December 13, 1976

Mr. Earl G. Wright
U.S. Nuclear Regulatory Commission
Radioisotopes Licensing Branch
Division of Fuel Cycle and Material Safety
Washington, D.C. 20555

This letter is intended to clarify several points in my application (control no. 84200) raised in your letter of November 24, 1976. My responses will follow your numbering.

FIGURE 1. Am-241 alpha/gamma exposure device
 ANTICIPATED SURFACE EXPOSURE RATE 21MR/hr.

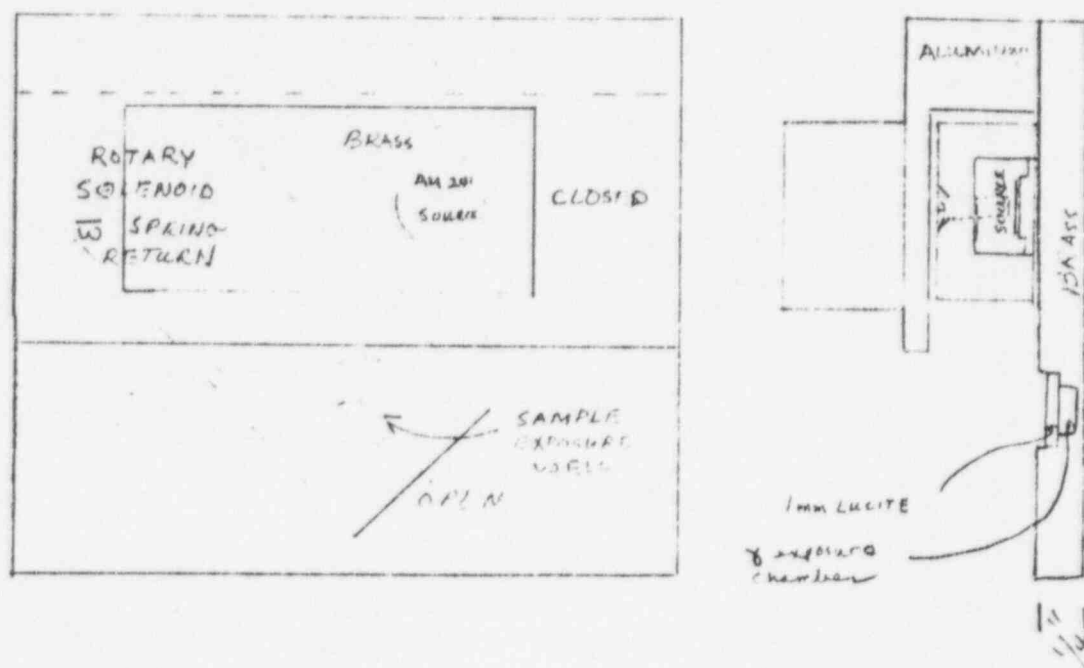
1. The americium-241 source is ICN model 74101. The number given in the application was that of the capsule type. The source will be stored and used in a shield fixture as shown in Figure 1. The 60 KeV gamma component will be used as a calibration for TLD personnel monitoring. The surface exposure rate on the device is anticipated to be less than 1 mR/hr. A wipe test on the exposure device will be made every three months when the source is in use.

FIGURE 2. Sr^{90} SHIELDED EXPOSURE DEVICE, ACTUAL SIZE.

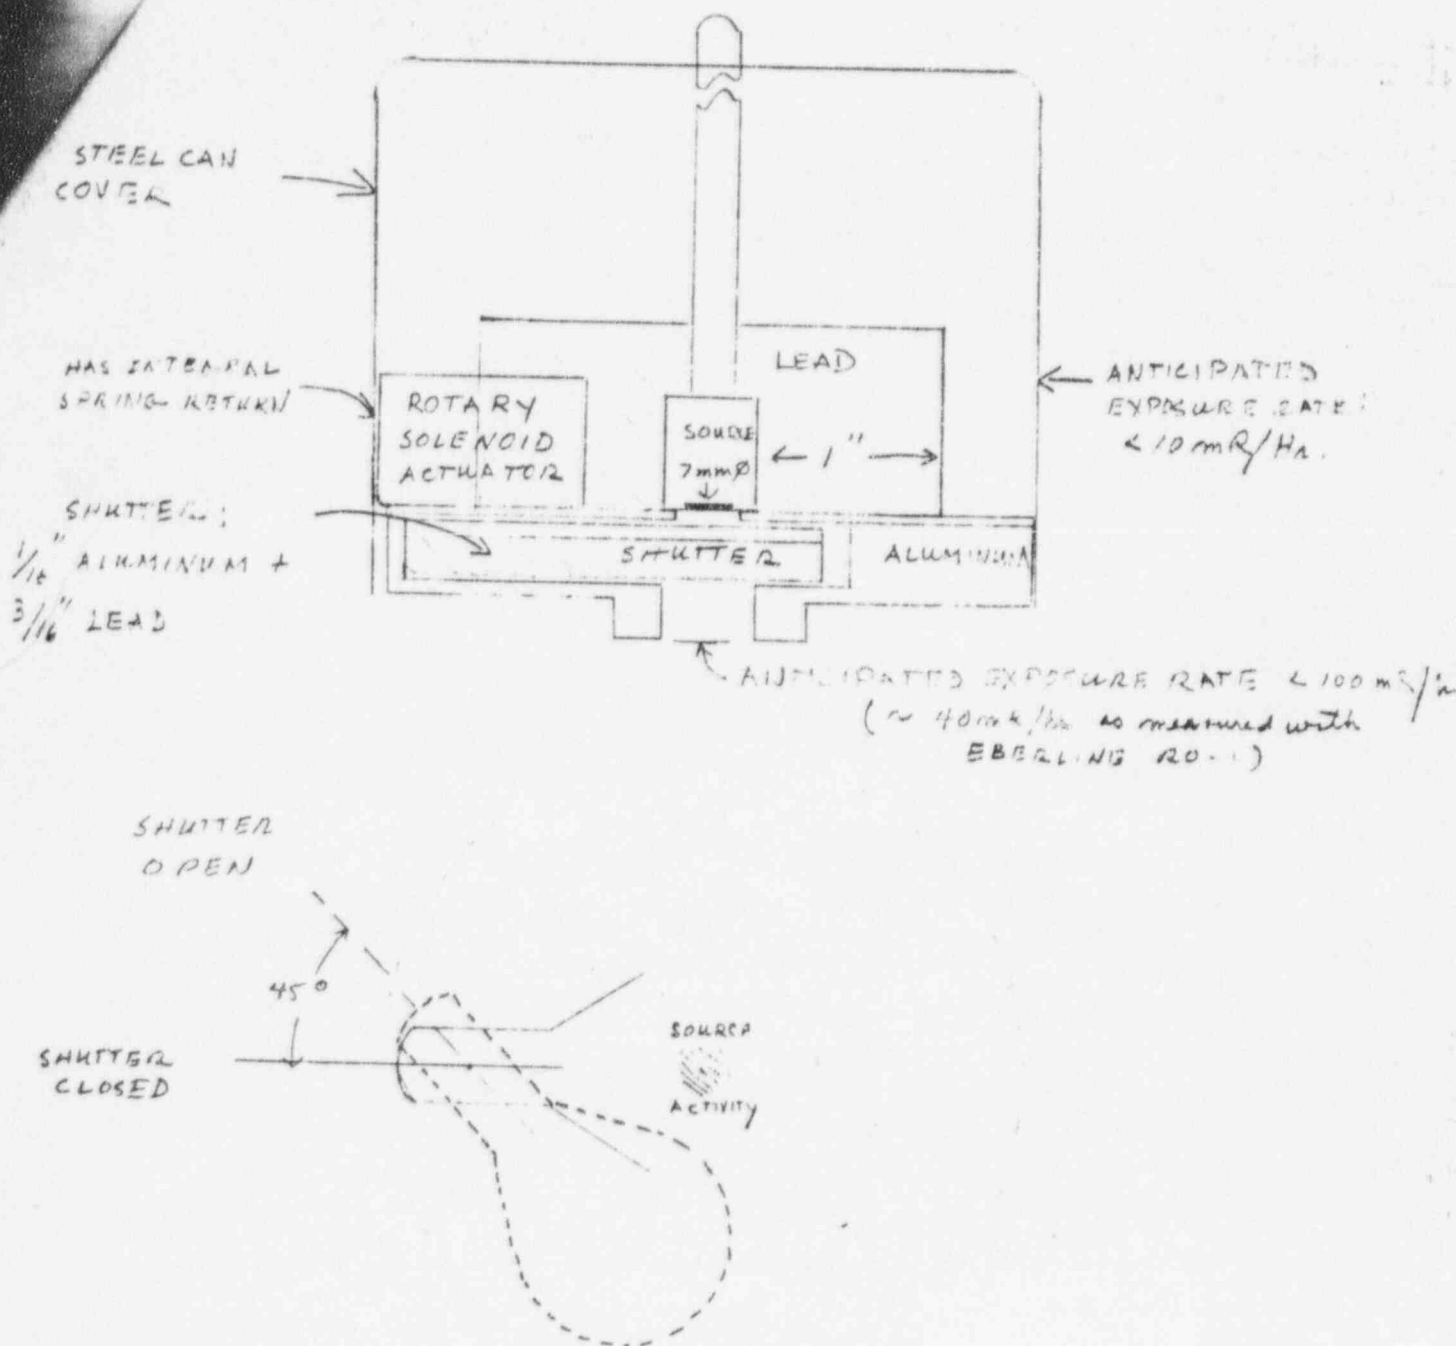
2a. The 100 mCi strontium-90 source (ICN 75129) will be stored and used in a shielded device having a solenoid operated spring return shutter. This will guard against mechanical damage and prevent personal contact with the source. A drawing of the proposed device is shown in Figure 2.

A composite shutter consisting of 1/16" aluminum and 3/16" lead was judged most effective in reducing bremsstrahlung production and then absorbing it. In the survey geometry described, the exposure rate was 45 mR/hr. The actual device will have a spacing ring which will prevent approach closer than about 1/2" to the bremsstrahlung-producing region of the shutter. I estimate that the actual exposure rate at the bottom of this ring will be no more than 100 mR/hr. When not in use, this assembly will sit on a 2" lead brick. The exit exposure rate will be under 10 mR/hr.

The top and sides of the source capsule will likewise be shielded. A $\frac{1}{2}$ " layer of lead reduced the top or side exposure rate to 12 mR/hr. Approximately 1" lead will be used.

TL LAB. LAYOUT

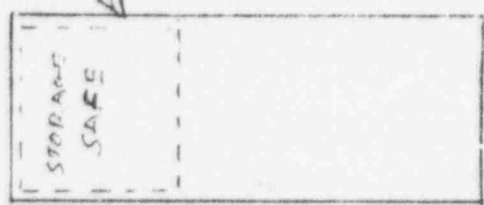
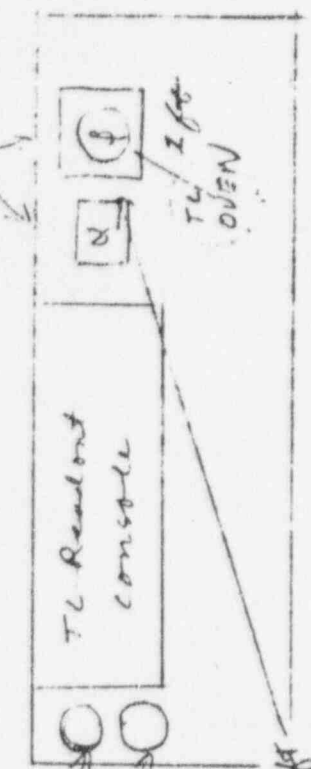
The expected use of the source should be less than 500 hours per year. A layout of the TL lab is shown in Figure 3.
